AECOM
Addendum No. 1

Project: Lexington City Hall Renovation
Lexington, Virginia

Addendum Date: 27 January 2025

Project No. 60730109

SHEET NUMBER
CD101

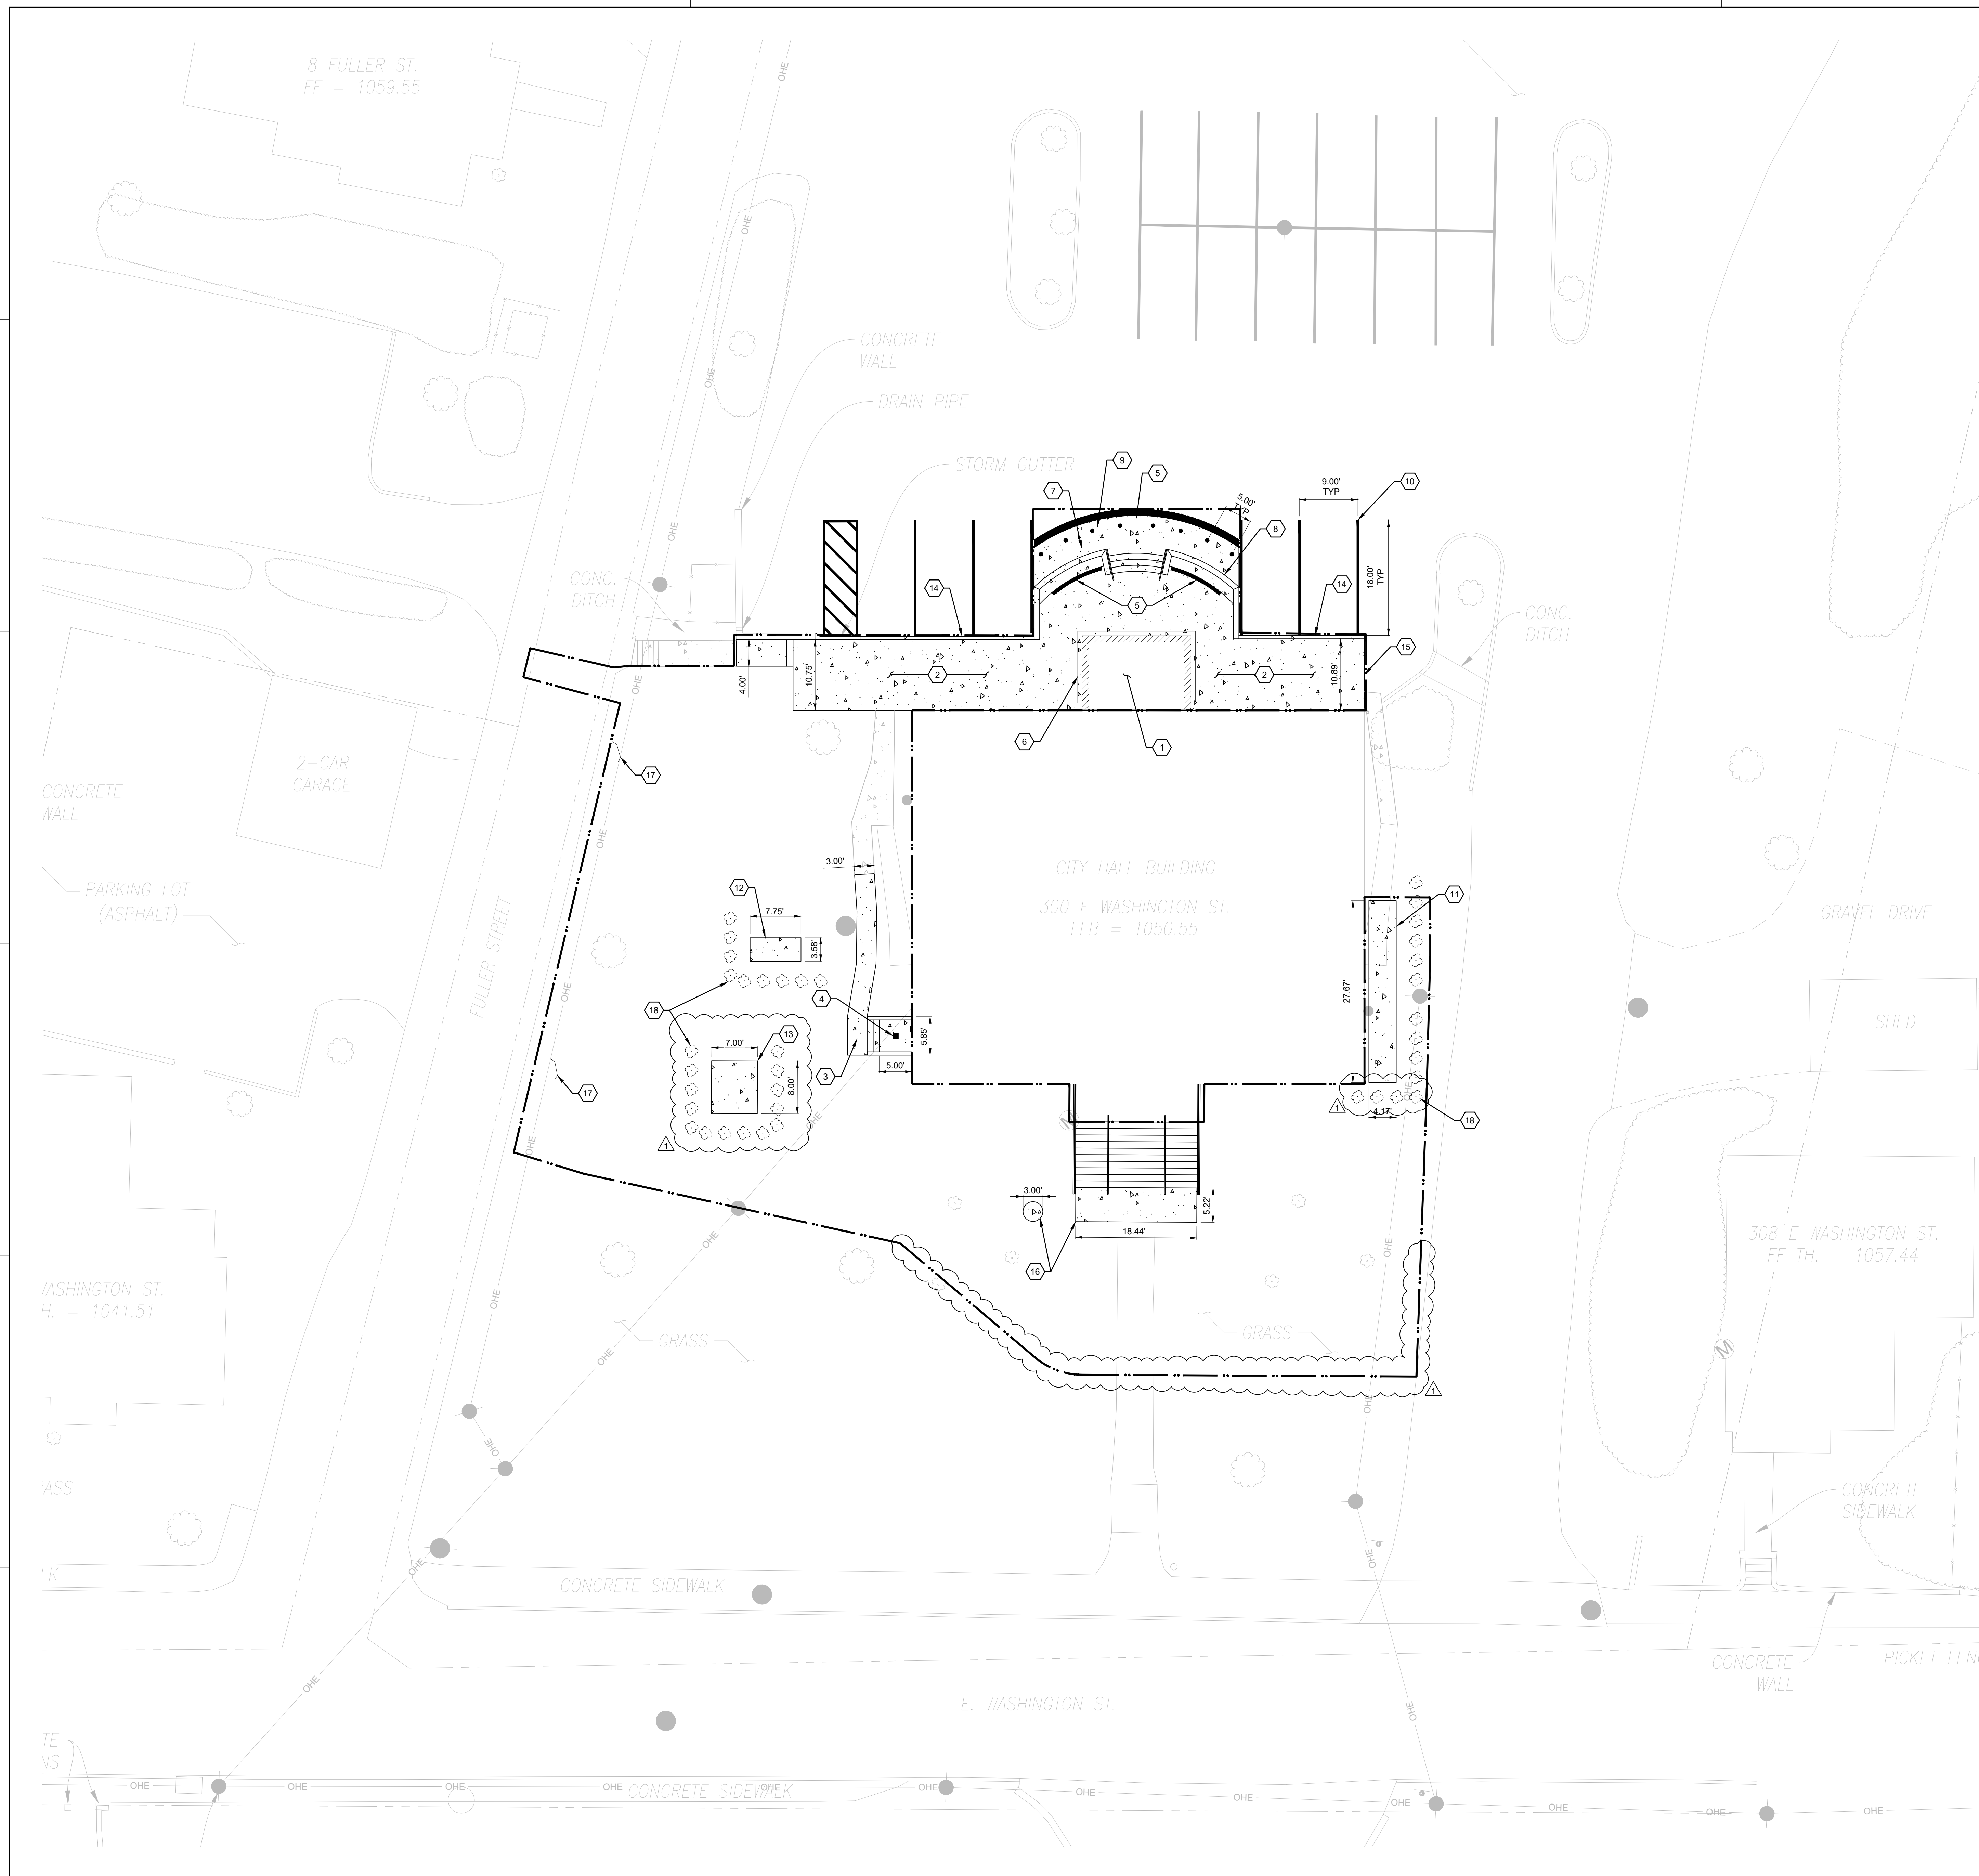
3. Question: Sheet CD101, Keynote 9: Sheet CD101, Keynote 9 states to see architectural Sheet AS100 for flagpole, front porch and sidewalk demolition details. There is no Sheet AS100 in the drawing set.
Response: See Addendum No. 1 revised Sheet CD101.
4. Question: Section 002513-1, page 19: How shall additional pre-bid site visits for bidders and subcontractors be handled? Who is the designated point of contact and how should site access be coordinated?
Response: Contact Doug Sisson, Lexington City Public Works at (540) 463-3154 to schedule a site visit time Monday through Friday, between 8:30 am and 3:00 pm.

9. DEMOLISH FLAGPOLE, FRONT PORCH, AND FRONT SIDEWALK AS INDICATED. SEE ARCHITECTURE SHEET AS101 FOR FLAGPOLE, FRONT PORCH, AND SIDEWALK DEMOLITION DETAILS.
